02-2017 LATEST REVISION DATE	 APPROVED BY BRIDGE ENGINEER	 STANDARD DESIGN - 40' ROADWAY, 3 SPAN BRIDGES <b>ROLLED STEEL BEAM BRIDGES</b> OCTOBER, 2014
		<table border="1" style="width: 100%;"> <tr> <td style="text-align: center;"> <b>FRAMING PLAN</b>  <b>220'-0" BRIDGE</b> </td> <td style="text-align: center;"> <b>RS40-047-14</b> </td> </tr> </table>
<b>FRAMING PLAN</b> <b>220'-0" BRIDGE</b>	<b>RS40-047-14</b>

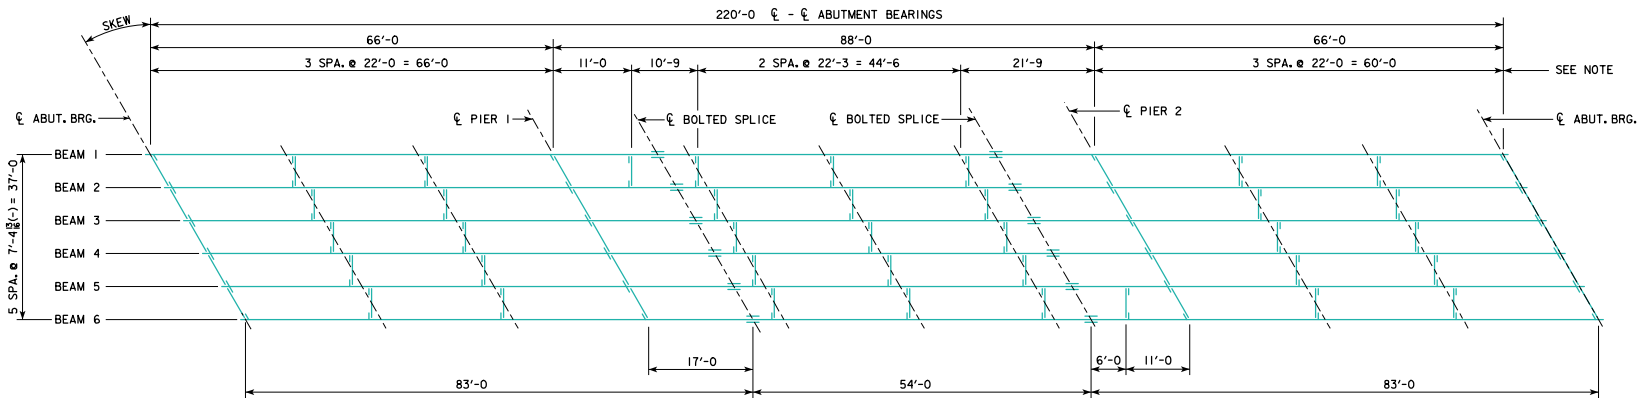
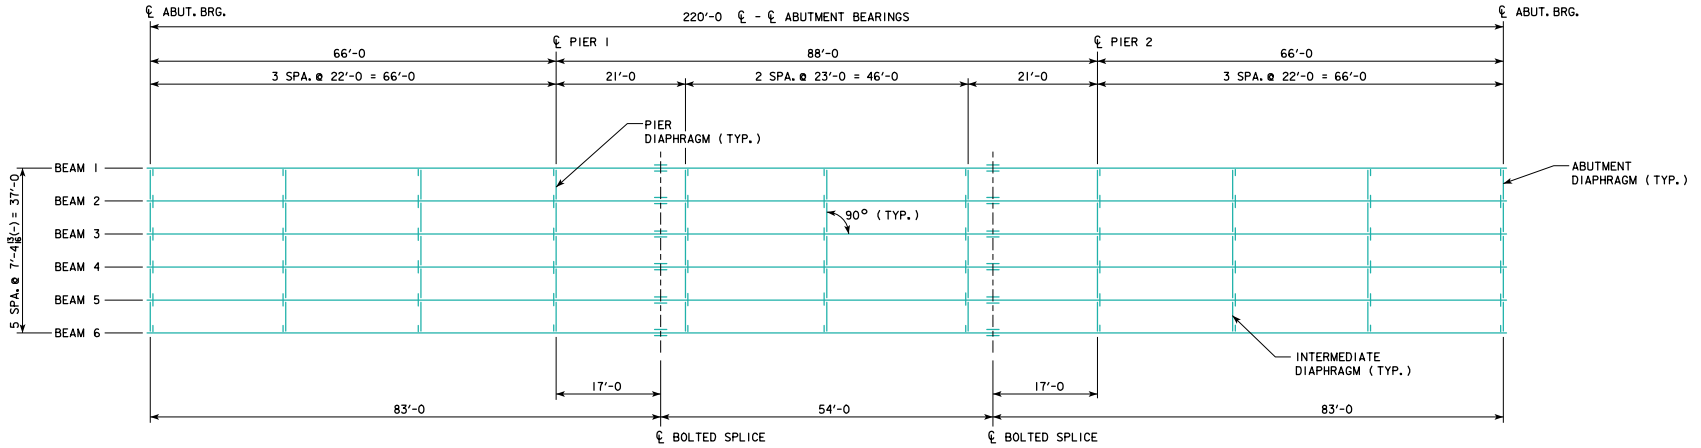
REVISED 02-2017 - CHANGED DIAPHRAGM SPACING IN ZERO SKEW FRAMING PLAN (WAS 4 SPACED AT 22'-0") IN 88'-0" CENTER SPAN, CHANGED DIAPHRAGM SPACING IN SKEWED FRAMING PLAN (WAS 4 SPACED AT 22'-0") IN 88'-0" CENTER SPAN, ADDED DIAPHRAGMS TO SKEWED FRAMING PLAN IN OUTER BAYS, BETWEEN BEAMS 1 & 2 AND 5 & 6 OF 88'-0" CENTER SPAN, 11'-0" FROM PIER CENTERLINES.
